Proposal for amendments to UN Regulation No. 107 (Buses and coaches)

The text reproduced below represents a common Romanian – CLCCR – OICA counter proposal to working document ECE/TRANS/WP.29/GRSG/2015/21. The modifications to the current text of Regulation are marked in **bold** for new or strikethrough for deleted characters.

Figure 12B

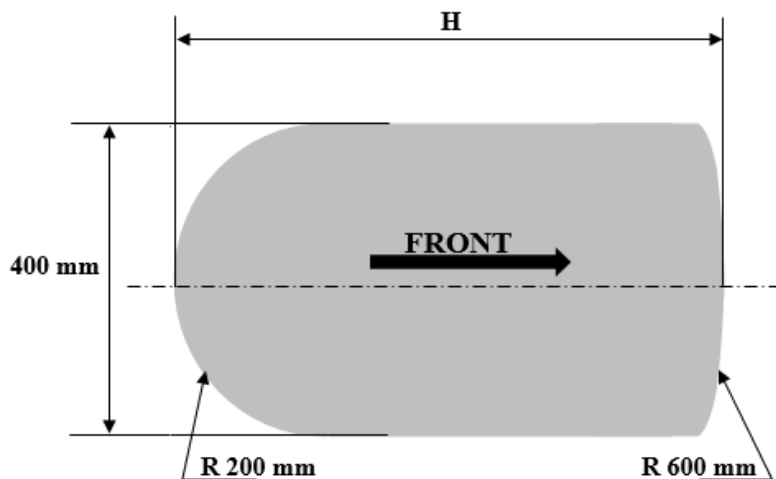
Annex 4, Figure 12, amend to read:

Testing gauge for H dimension (see Annex 3, paragraph 7.7.8.4.2.)

Thickness of the gauge: 5 mm maximum

6. Generally the bottom of the squab of passenger seats is curved (especially for Class B and III vehicles) to provide best comfort to the occupants. The rear part of the new proposed gauge aims at reflecting the shape of the human back, and the radius of the front aims at simulating the rotation of the knees around the hips.

7.7.8.4.2. All measurements shall be taken, with the seat cushion and squab uncompressed, ~~in a vertical plane passing through the centreline of the individual seating place~~ **using the testing gauge shown in Annex 4, Figure 12B.**"
